Submissions and Preferred Infrastructure Report

Newcastle Inner City Bypass
Rankin Park to Jesmond

Newcastle Inner City Bypass – Rankin Park to Jesmond Submissions and preferred infrastructure report

Roads and Maritime, as the proponent of the project, has prepared this submissions and preferred infrastructure report to respond to issues raised in submissions and describe and assess design refinements made since the exhibition of the EIS.

Figure 5-1a
The project

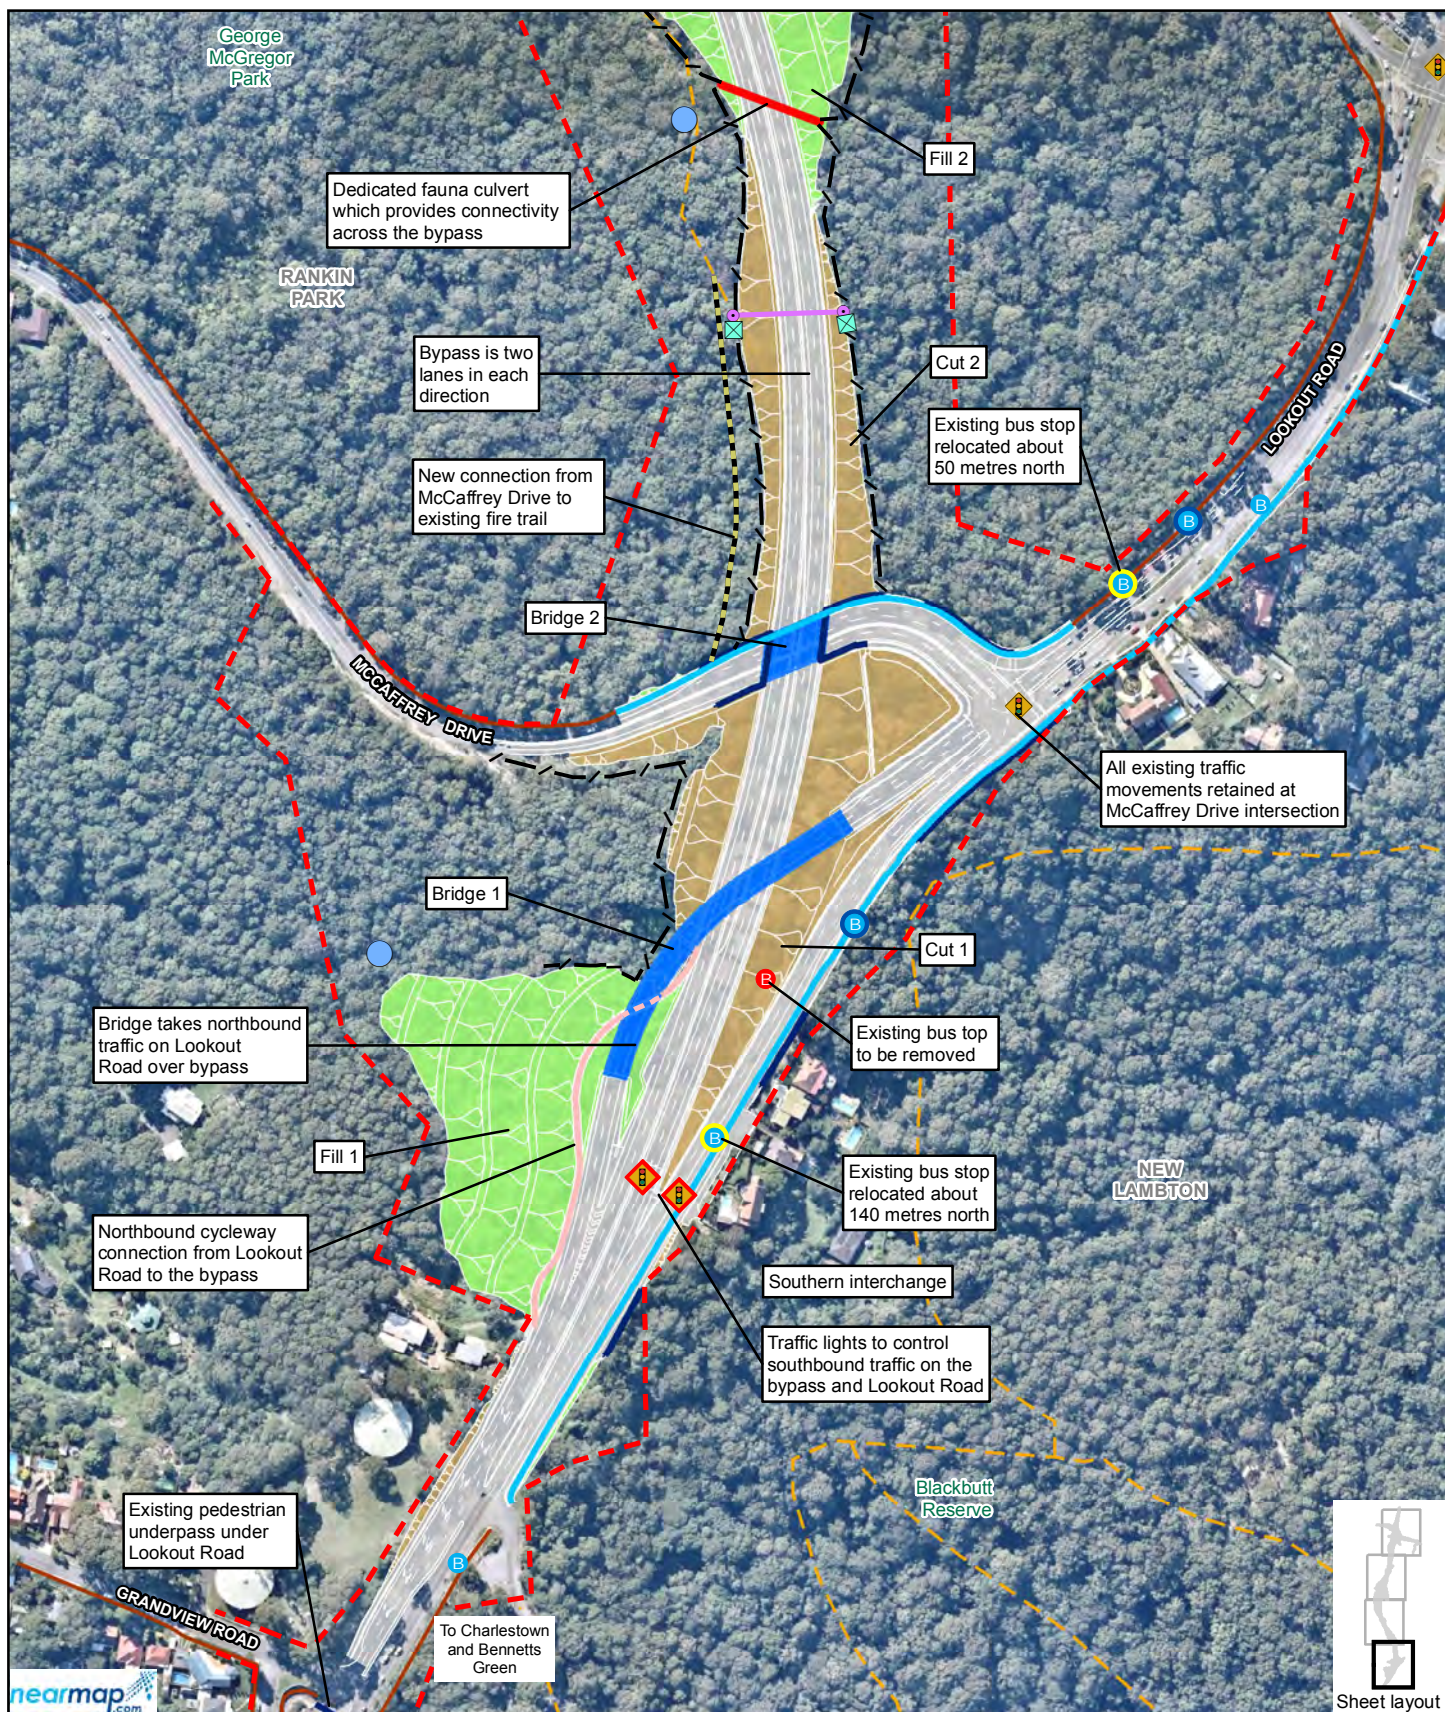
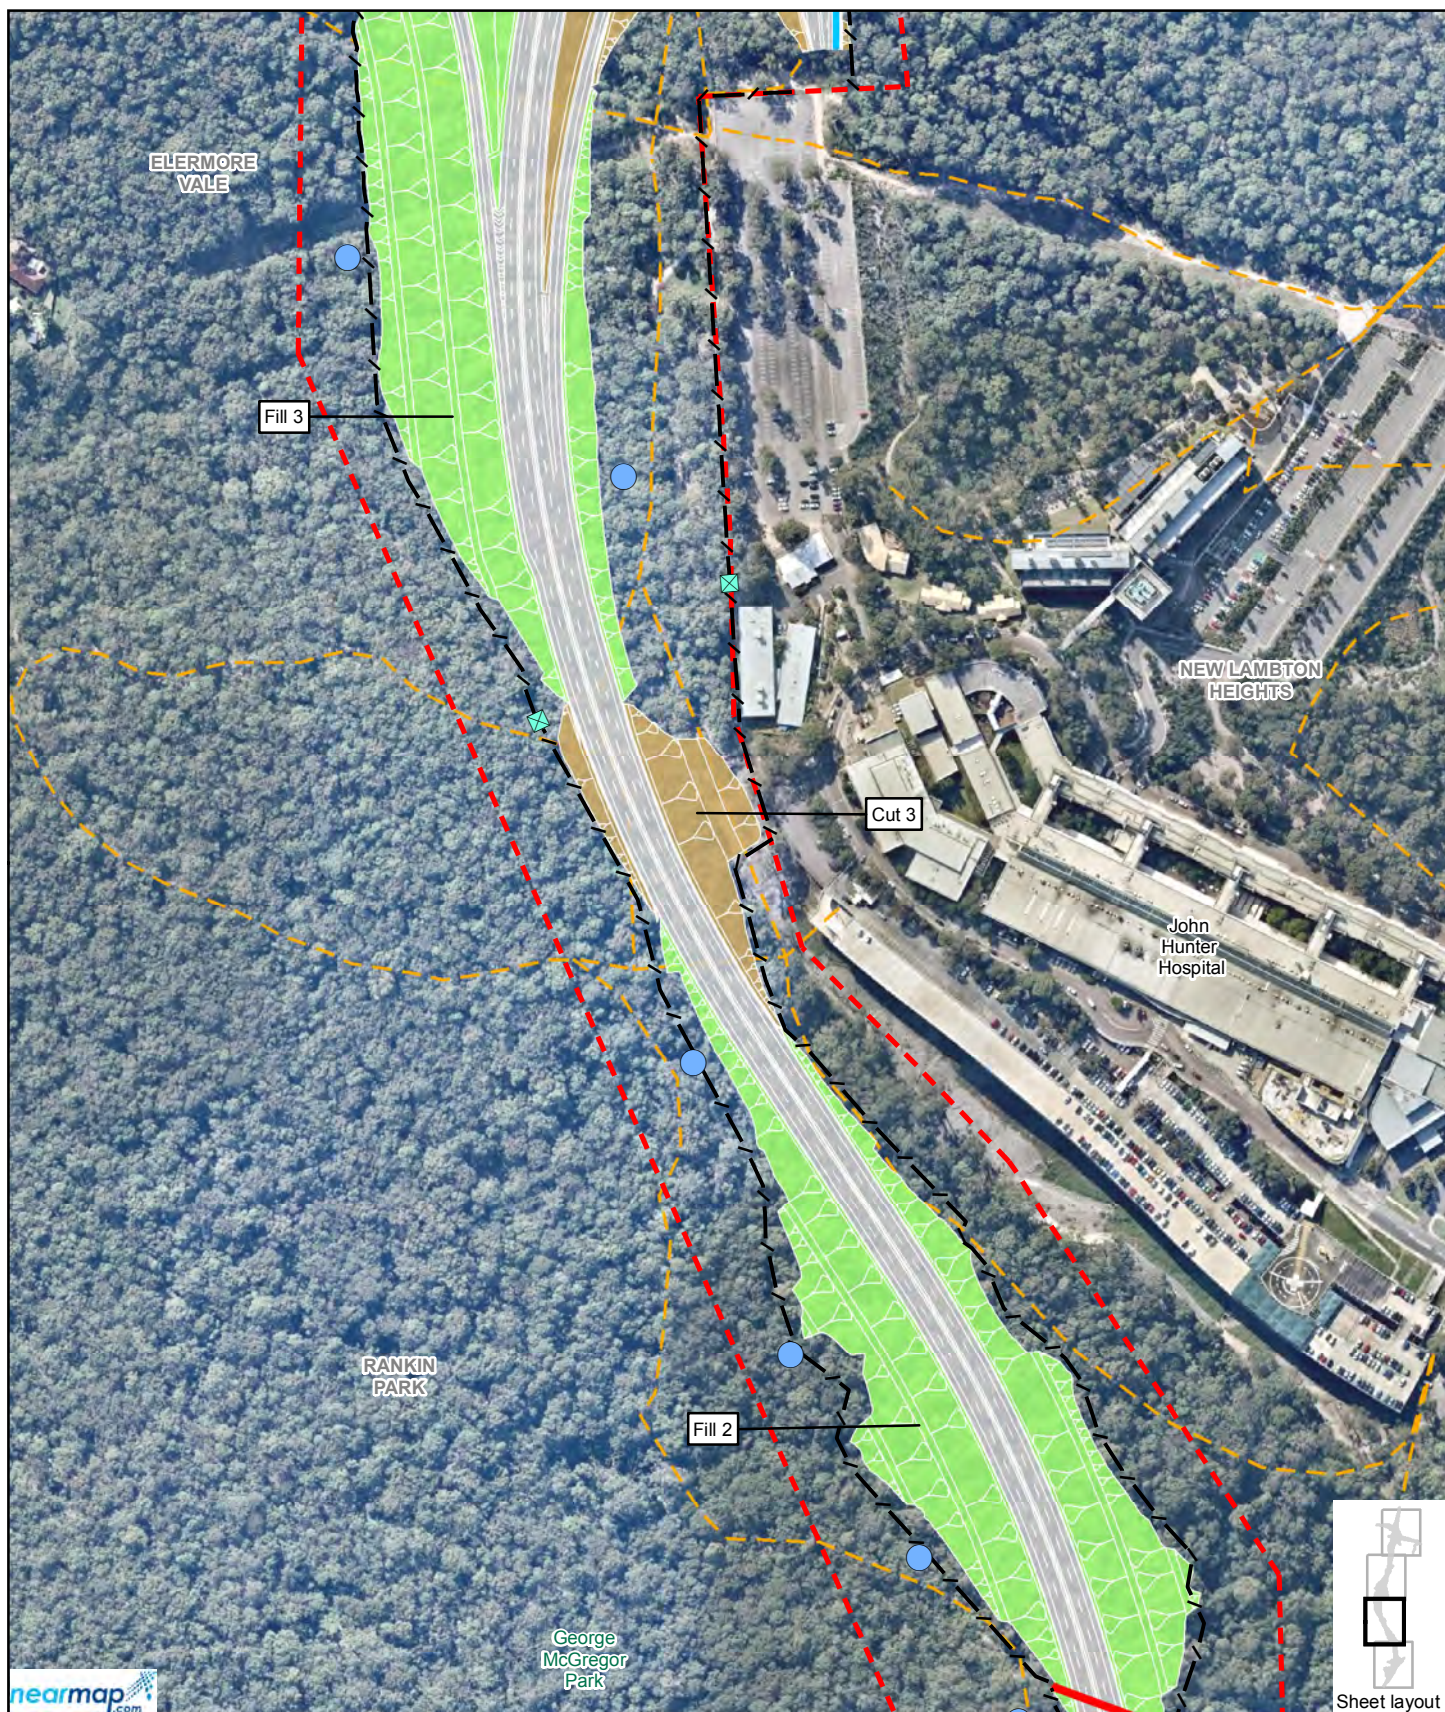
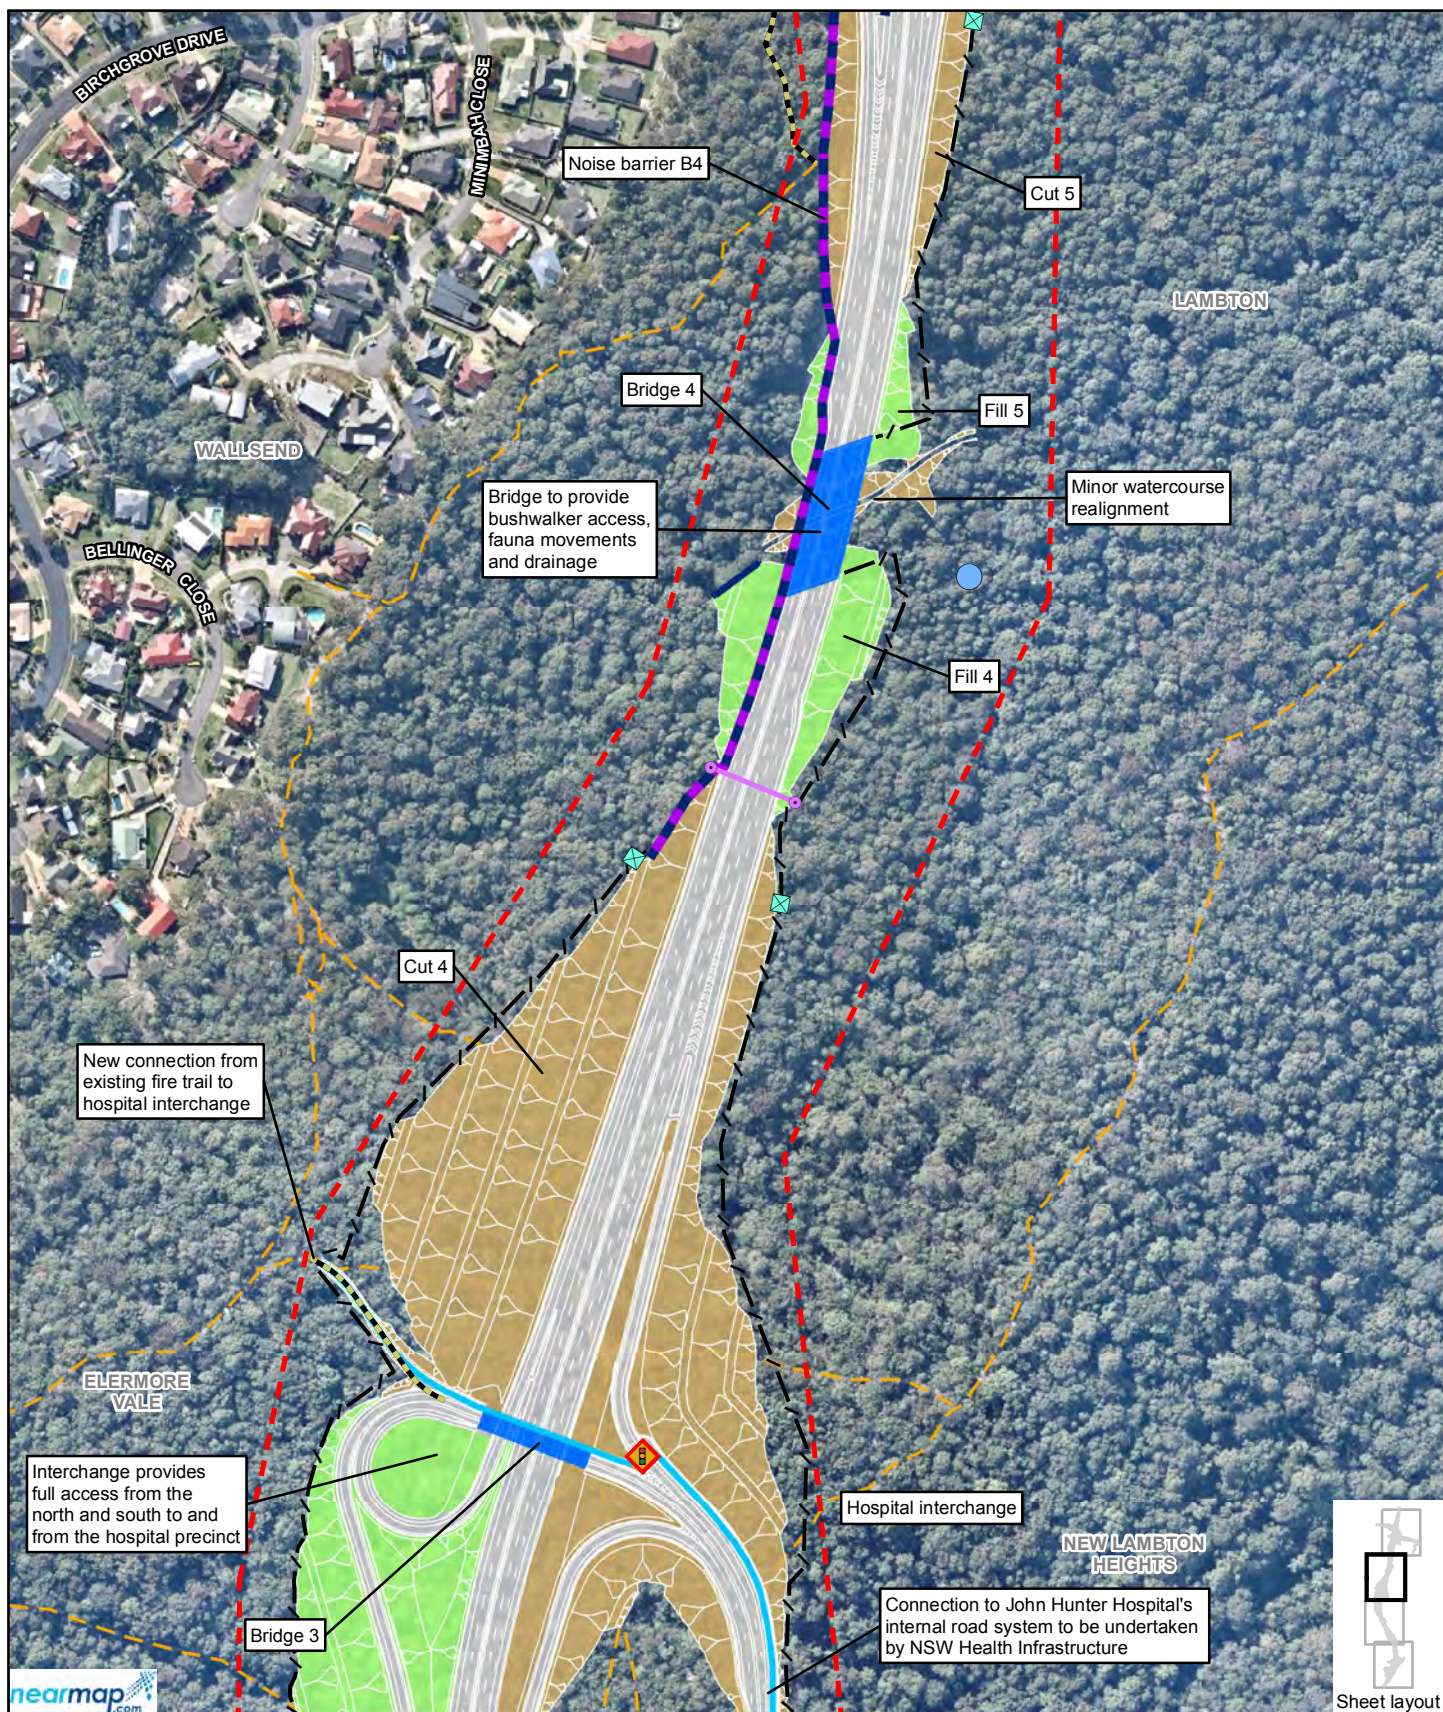
These are described in the following sections and key refinements are shown in Figure 5-1.

The key features of the project (including the proposed design refinements) (Figure 5-1) include:

To assist with ongoing water quality control during operation of the project it is now proposed to retain and modify eight of the construction sedimentation basins as operational water quality treatment structures, as shown in Figure 5-1. Vegetated swales are also proposed to be constructed along batters as operational water quality treatment structures. Vegetated swales are proposed to be constructed where batter grades are suitable (where batter grades are between one and five per cent). These structures would capture stormwater runoff from all operational areas of the project (excluding existing roads).
